## **ALERT SERVICE BULLETIN** **ASB No. AA-06025**

**SUBJECT:** **Replacement Handle Kit**  
P/N 407-564-033 / 407-564-034

**MODELS AFFECTED:** Bell Helicopter Textron Model 407 with  
Aeronautical Accessories, Inc.  
P/N 407-564-101 / 407-564-102  
Passenger Photo Window Assembly installed  
in accordance with STC SR09324RC or  
STC SR09324RC-D.

**DESCRIPTION:** This Alert Service Bulletin is being issued in  
response to reports of Passenger Photo Window  
Slider Assemblies becoming dislodged from their  
tracks and departing the aircraft while in flight.

**FIGURE 1 – HANDLE ASSEMBLY INSTALLATION**

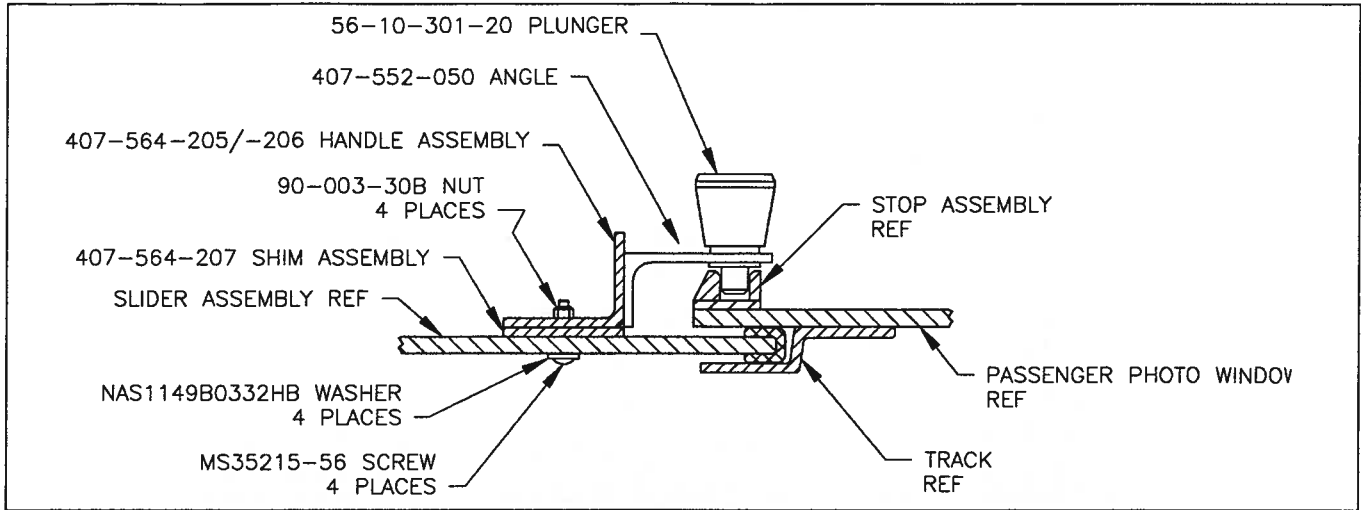
5. Install the Shim Assembly and Handle Assembly on the Slider Assembly with hardware, as shown in Figures 1 and 2.
6. Install the Plunger (56-10-301-20) into the Angle (407-552-050) using Adhesive (099-050-171), as shown in Figure 1.
7. With the Slider Assembly in the full-closed position, center the Angle assembly on the Handle Assembly.
8. Ensuring proper engagement of the Plunger inside the Stop, transfer the hole pattern from the Angle to the Handle Assembly (Ref. Figure 2).
